HDP – EMC Areas Review

Hematite Decommissioning Project

EMC Investigation Area within LSA 02-01

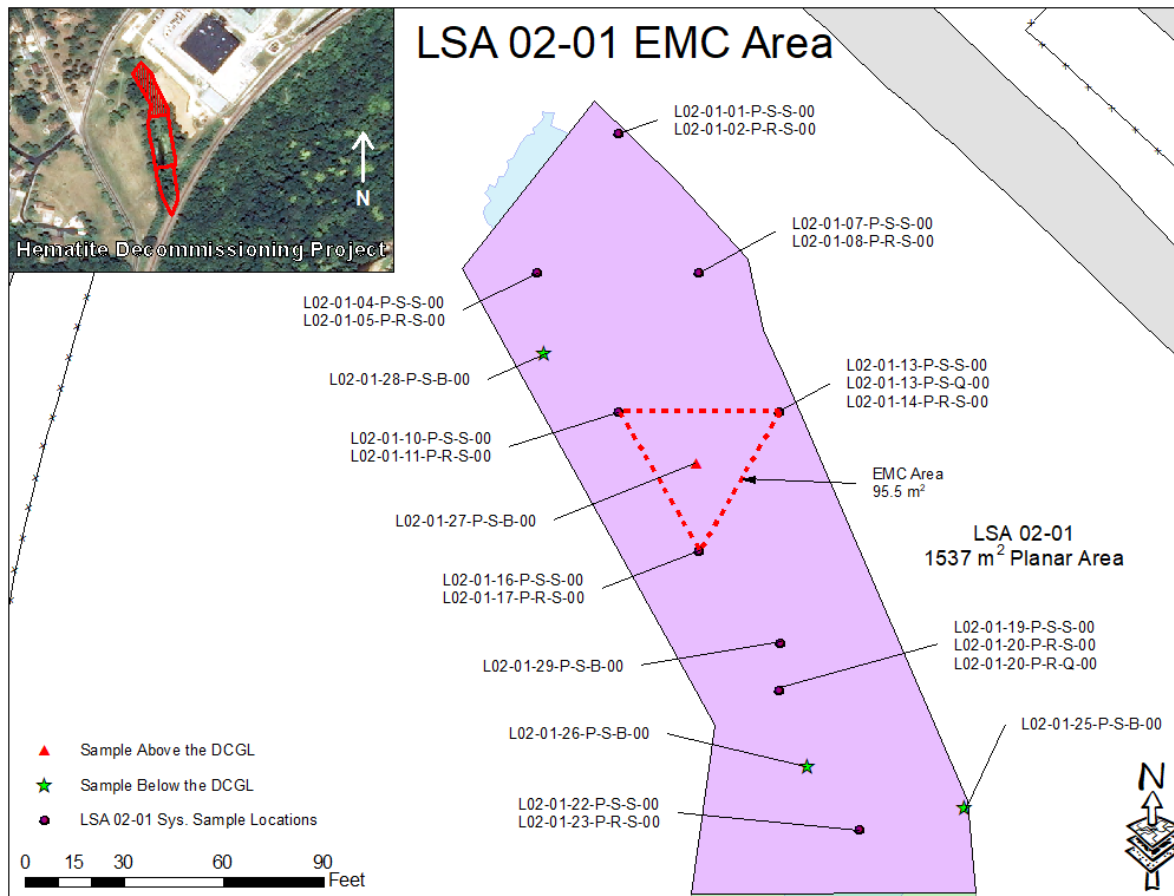
The size of the associated elevated area surrounding this biased location was determined by using the nearest “clean” systematic locations to define a polygonal area of 95.5 m² as calculated by GIS software.

EMC Investigation Area within LSA 02-02

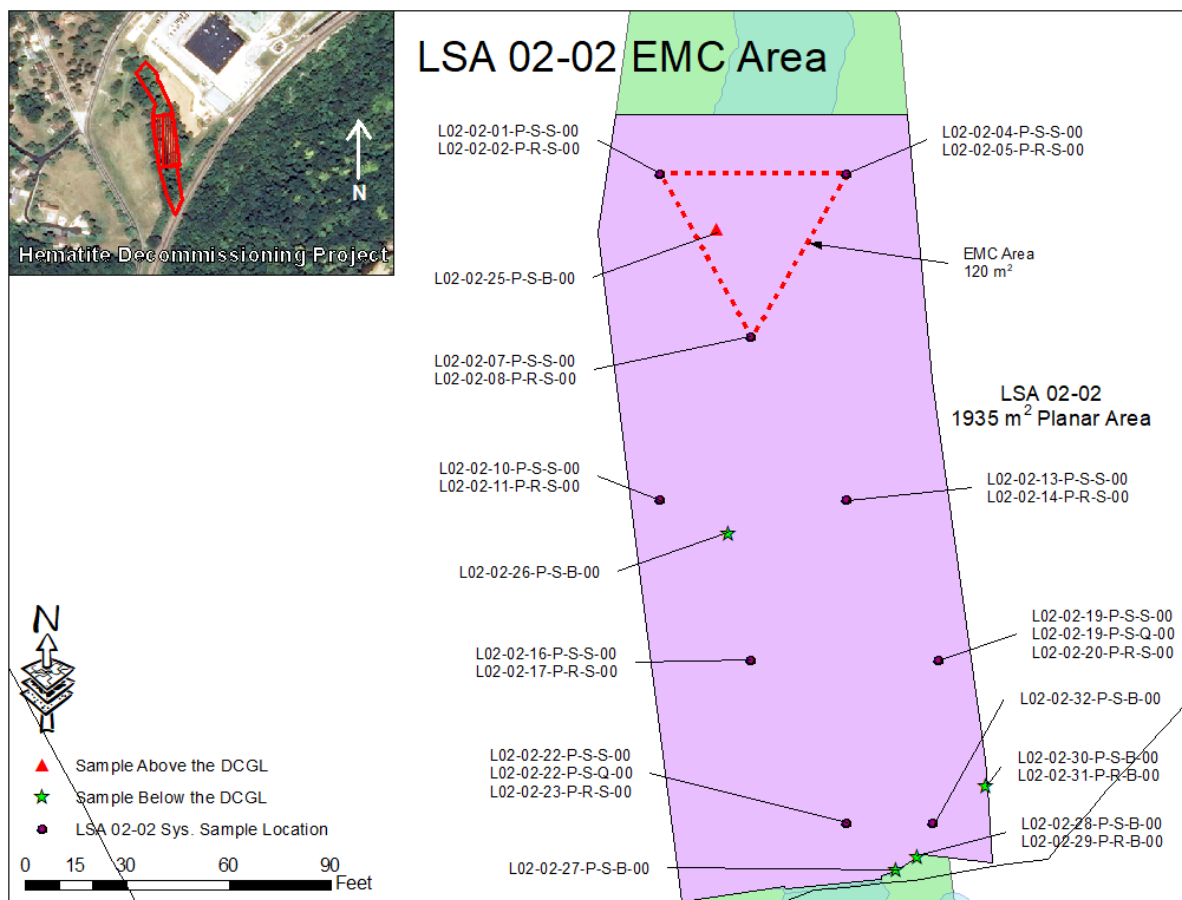
The size of the associated elevated area surrounding this biased location was determined by using the nearest “clean” systematic locations to define a polygonal area of 120 m² as calculated by GIS software.

EMC Investigation Area within LSA 02-03

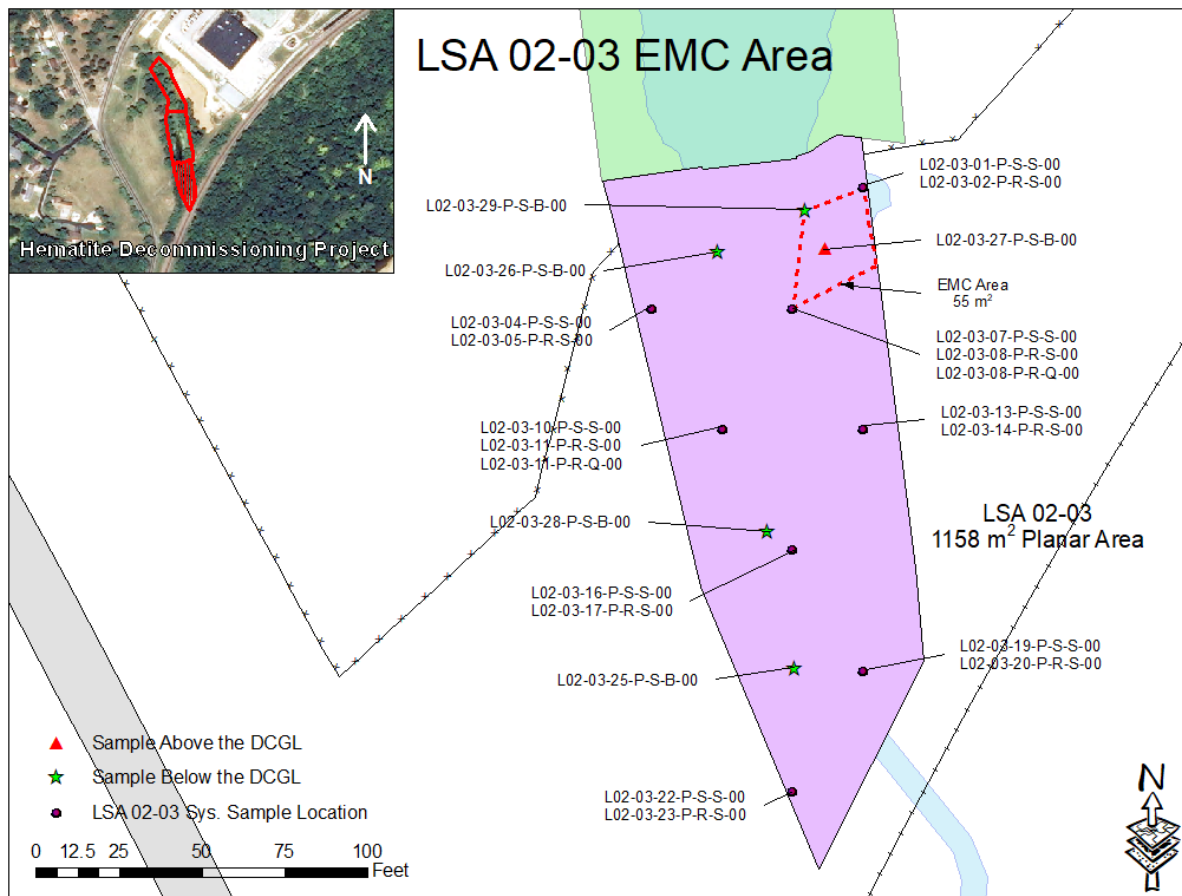
The size of the associated elevated area surrounding this biased location was determined by using the nearest “clean” systematic locations, biased sample locations, and the boundary of the SU to define a polygonal area of 55 m² as calculated by GIS software.

While it was not specifically stated in the FSSR for LSA 02-03 (Volume 3, Chapter 22) that scanning was also used to determine that the EMC area did not extend beyond the SU boundary, since the elevated area was due to Uranium a review of the GWS data does indicate that the area is very small, and clearly does not extend outside of LSA 02-03.

EMC Investigation Area within LSA 05-01

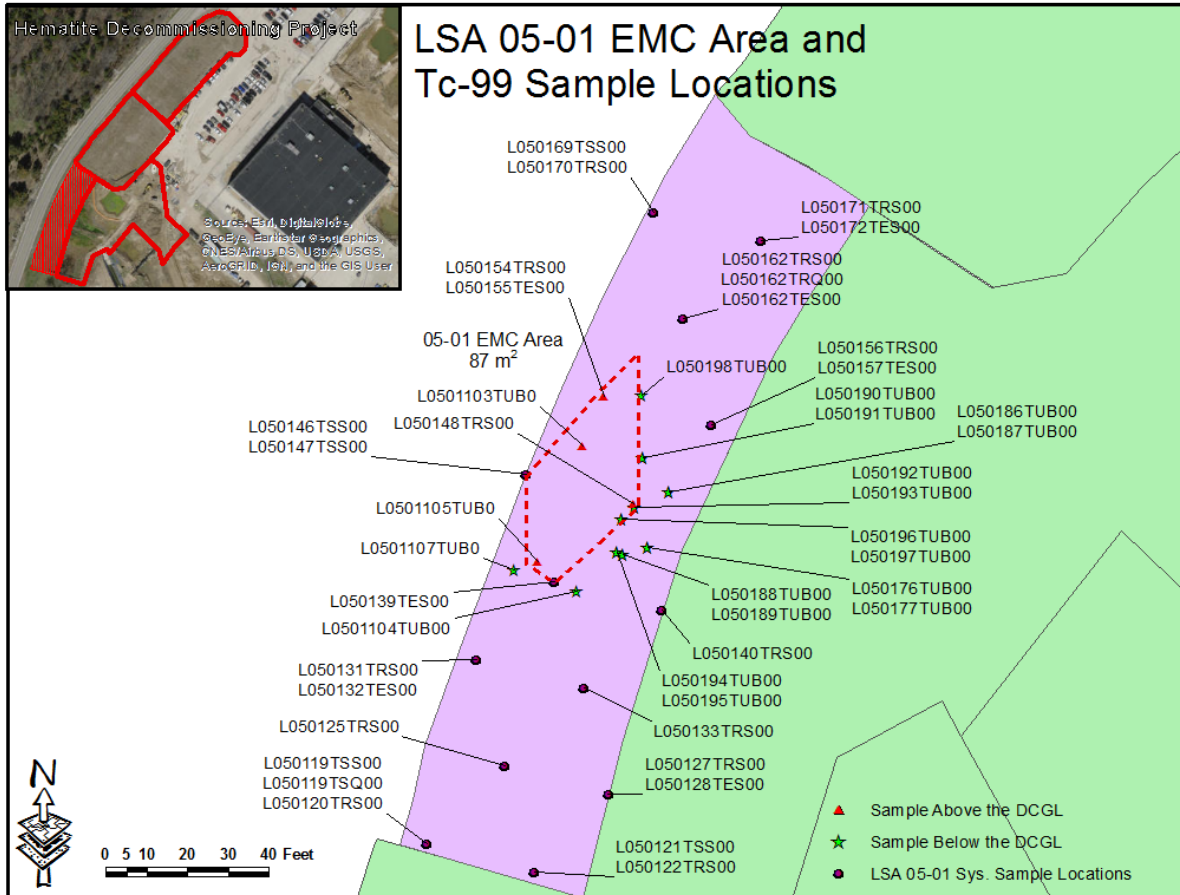
The size of the associated elevated area surrounding this biased location was determined by using the nearest “clean” systematic and biased locations to define a polygonal area of 87 m² as calculated by GIS software. This 87 m² polygon was placed around the elevated biased sample locations to define the area where the elevated sample activity remains within the SU. To the East, South, and West of the EMC area, there were a significant number of “clean” samples, creating a clear boundary. However to the North of the EMC area, there was less available sample data which required the Health Physics Staff to rely on professional judgment. Since LSA 05-01 borders a public roadway (State Road P), and excavation into the “right of way” of the roadway was limited by the Missouri DOT, less excavation (and thus less sampling) was performed in this area. Three elevated samples were identified to remain in the Northern portion of the EMC area. While there is less available “clean” sample data creating an easily defined boundary to the North, the area in question is still relatively small. There is less than 15 feet in linear distance from each of the elevated samples, to the nearest “clean” sample. Given these factors, the Health Physics Staff placed the Northern EMC boundary so that the three elevated sample points were completely enclosed within the 87 m² polygon, and that the all systematic samples collected above the Northern most boundary of the EMC area were significantly less than the DCGLs.

Furthermore, the Health Physics Staff considered given the radiological conditions of the EMC area what the maximum size of the EMC are could be without exceeding a SF of 1.0 for the survey unit. Evaluations determined that the area of the EMC would have to exceed 500 m² in order for the EMC evaluation to be unsuccessful. Knowing that the allowable maximum area is significantly larger than the actual estimated area provides an additional layer of confidence, but the purpose of the EMC evaluation is to determine the actual radiological conditions that remain in the area, not the allowable maximum, therefore the 87 m² polygon is considered appropriate.

EMC Investigation Area within LSA 08-01

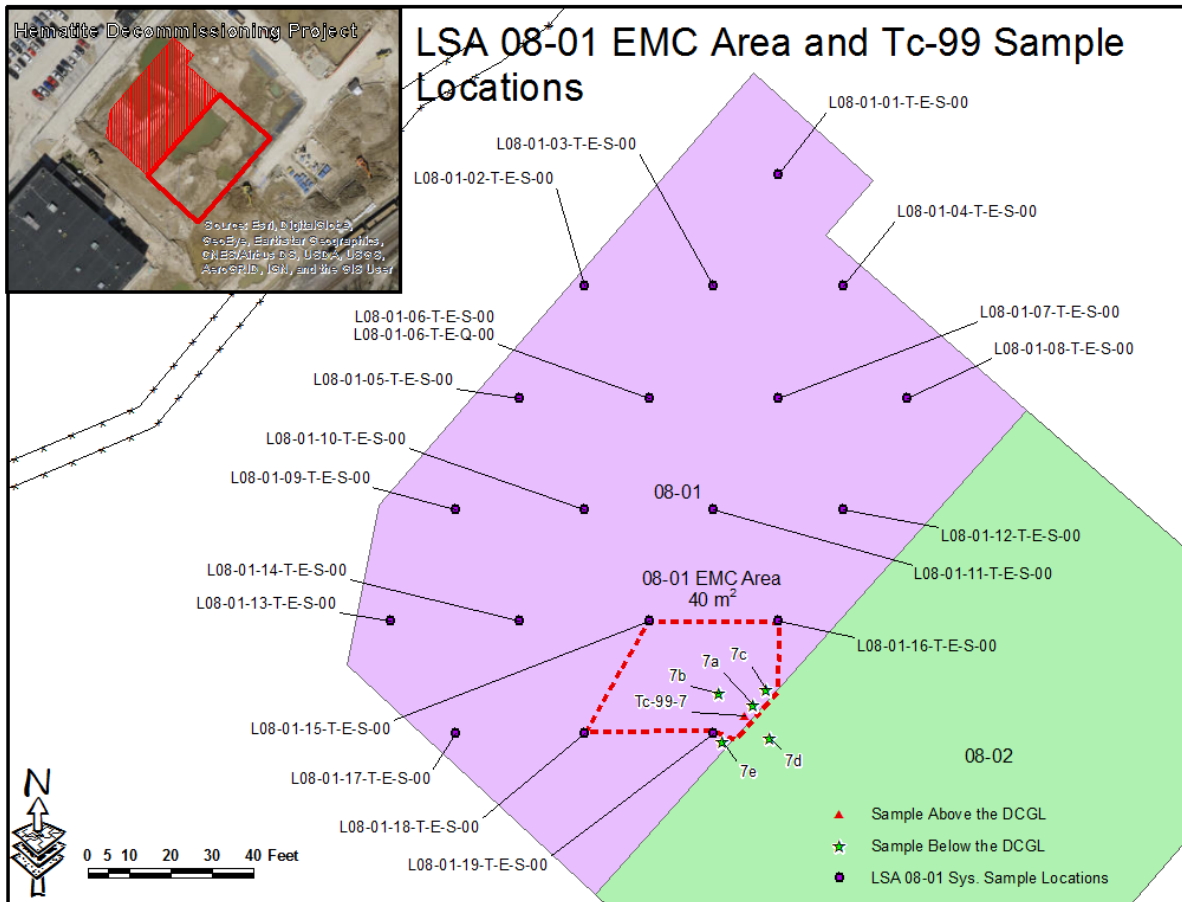
The size of the associated elevated area surrounding this biased location was determined by using the nearest “clean” systematic and biased locations and the boundary edges of the SU itself to define a polygonal area of 40 m² as calculated by GIS software.

While not specifically stated in the FSSR for LSA 08-01 (Volume 3, Chapter 12), sample points 7d, and 7e in the figure below were included to provide additional confidence that the general size of the elevated area is relatively small compared to the larger “assumed” EMC Area. Using sample points 7b, 7c, 7d, and 7e in the figure below, the EMC area could be estimated to be 14 m². However this smaller area was not used as point 7d is in the neighboring LSA 08-02.

Since the estimated AF of 40 m² was chosen to be sufficiently conservative, and the SU still passed the EMC evaluation, it was determined that additional sampling would not be beneficial as it would only serve to reduce the estimated dose for LSA 08-01.

EMC Investigation Area within LSA 08-10

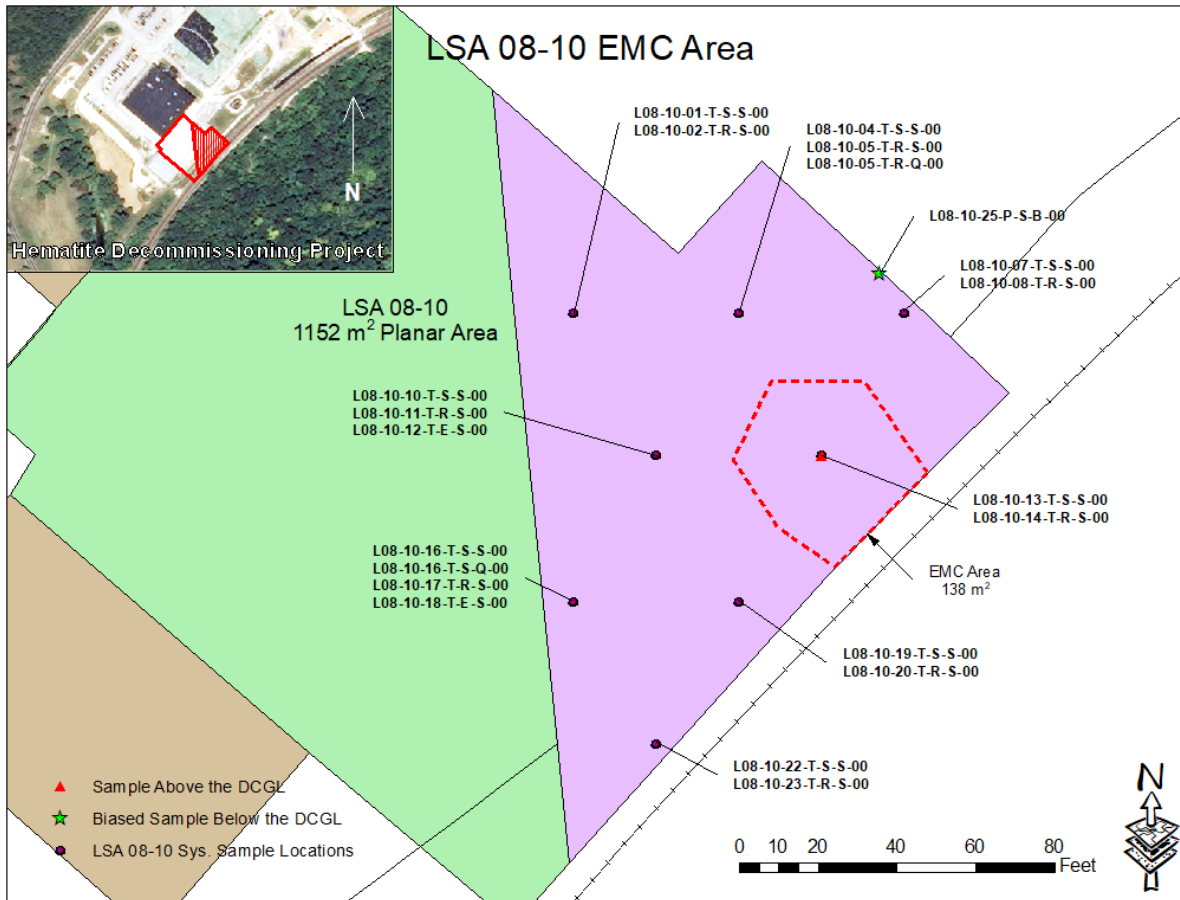
One sample in LSA 08-10 was identified to contain elevated levels of Tc-99 as indicated by the analysis, performed at the offsite laboratory, of the systematic soil samples collected in the SU. While no individual nuclide within the sample exceeded the appropriate DCGL_w, the SOF for the sample (1.11) did exceed a Uniform SOF value of 1.0.

Therefore, an Elevated Measurement Comparison (EMC) evaluation was performed for LSA 08-10 as required by Procedure HDP-PR-FSS-721 Final Status Survey Data Evaluation. The size of the associated elevated area surrounding this location was determined by using half the distance to the nearest “clean” systematic locations and the boundary edges of the SU itself to define a polygonal area of 138 m² as calculated by GIS software. Following the steps presented in Section 8.6.7 of HDP-PR-FSS-721, the DCGL_{EMCS} for all nuclides were calculated based on the nuclide-specific area factors corresponding to 138 m².

While not specifically stated in the FSSR for LSA 08-10, the following assumptions were made to determine the estimated size of the EMC area. Review of previously performed characterization data showed no other similar areas of elevated activity, and the GWS data did not indicate the presence of any elevated gamma measurements. As no individual nuclide exceeded the individual DCGL_w, and characterization data supports the conclusion that the slightly elevated contamination is not widespread, the elevated area was assumed to be very small in nature. In order to determine how large a hypothetical hot spot could be and still meet the unrestricted release criteria, a reverse EMC calculation determined that at these soil concentrations the hot spot would have to exceed 500 m² before additional remedial actions became necessary for the SU to meet release criteria.

Next, in an attempt to accurately estimate the appropriate size of the elevated area, the distribution of the systematic samples was reviewed. Since each systematic sample spatially represent a certain portion of the SU, the elevated area was estimated by using half the distance to the nearest “clean” systematic locations and the boundary edges of the SU itself to define a polygonal area (as seen below). While it is still assumed that the elevated area is quite small in nature, it was determined that by expanding the EMC area all the way to the SU boundaries the estimate of 138 m² was sufficiently conservative, and more accurately reflected the residual dose in the SU compared to using the “hypothetical worst case” scenario.

EMC Investigation Area within LSA 08-01

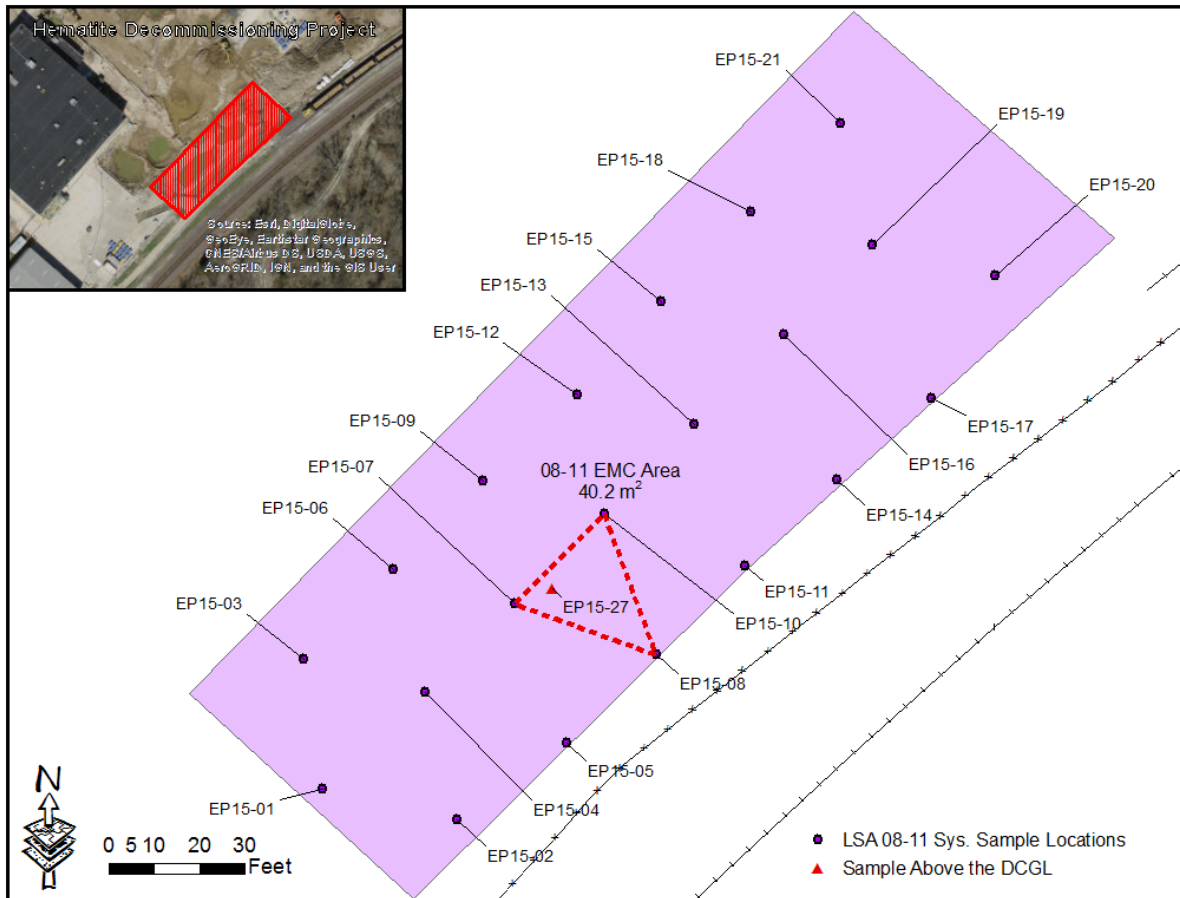
LSA 08-11 provides a good example in which an area of elevated Tc-99 activity was identified, and the surrounding “clean” systematic samples were used to determine the elevated area boundary. As the area of the triangular grid in which the elevated area is located, as defined by systematic soil sample location was 40.2 m². Therefore an AF of 40.2 was assigned and determined to be sufficiently conservative to perform the EMC evaluation to ensure compliance with the release criteria.

The size of the associated elevated area surrounding this biased location was determined by using the nearest “clean” systematic and biased locations and the boundary edges of the survey unit itself to define a polygonal area of 40.2 m² as calculated by GIS software.

EMC Investigation Area within LSA 08-12

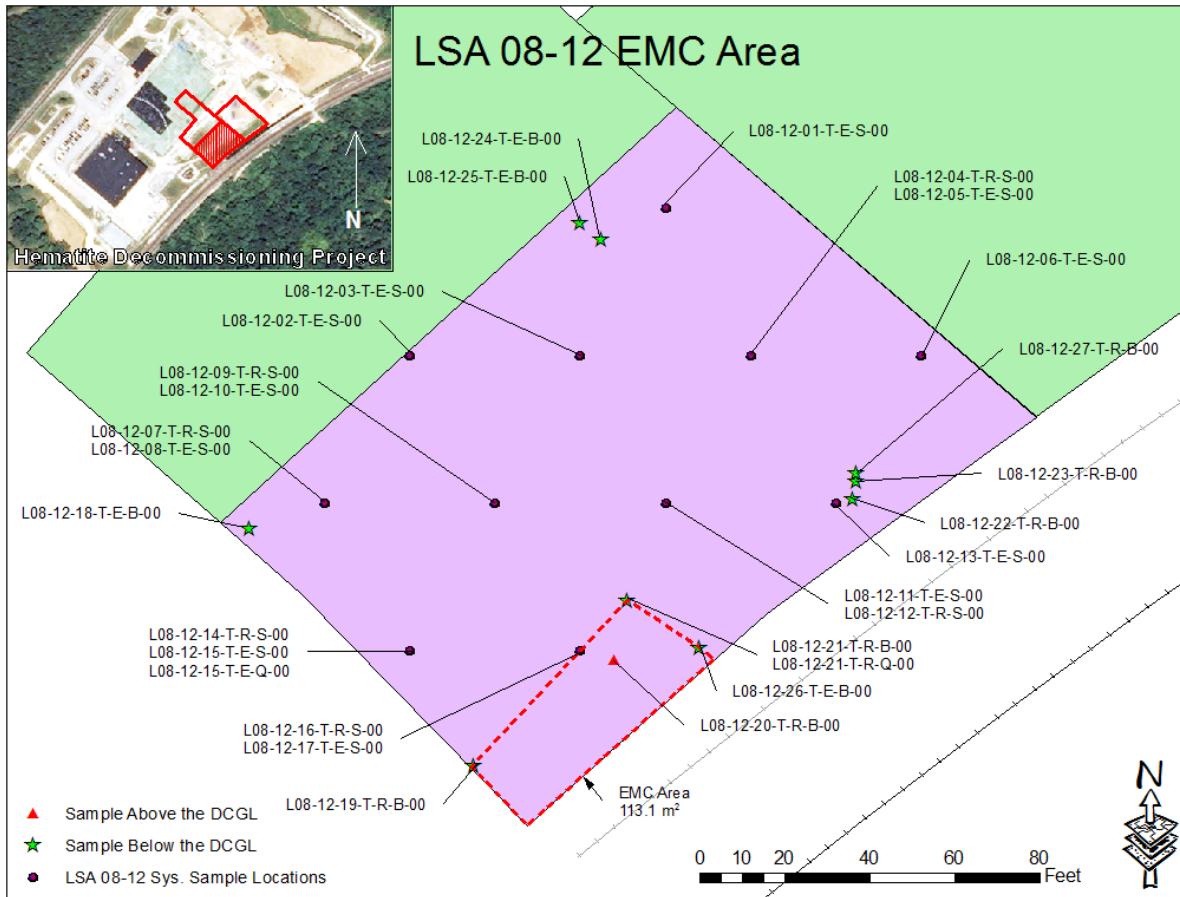
The size of the associated elevated area surrounding this biased location was determined by using the nearest “clean” systematic and biased locations and the boundary edges of the survey unit itself to define a polygonal area of 113.1 m² as calculated by GIS software.

While not specifically stated in the FSSR for LSA 08-12, the following assumptions were made to determine the estimated size of the EMC area. Review of the surrounding sample data showed that the nearest three clean sample points were approximately 10, 15, and 20 feet away from the elevated area respectively, indication that the EMC area is quite small. So the decision was made to conservatively expand the EMC area outward to the survey unit boundaries in order to give a high level of confidence that the elevated area had been completely encompassed and accounted for in the final survey unit dose assessment.

NOTE: During review of the LSA 08-12 data, a minor typographical error was identified that will require correction, and re-submittal of Volume 3, Chapter 21, to Revision 2 (LSA 08-09, LSA 08-12 and LSA 08-13). The EMC determination inadvertently used the Excavation DCGLs, when the Root DCGLs should have been used, thus slightly increasing the EMC dose estimate from 1.25 mrem/year to 3.5 mrem/year. The Root AFs were properly applied, as were all other applicable DCGLs to the remaining soil samples in the survey unit. The survey unit still meets the unrestricted release criteria, with a survey unit total dose estimate of 11.68 mrem/year (using the final ground water dose contribution), well below the 25 mrem/year dose criteria.
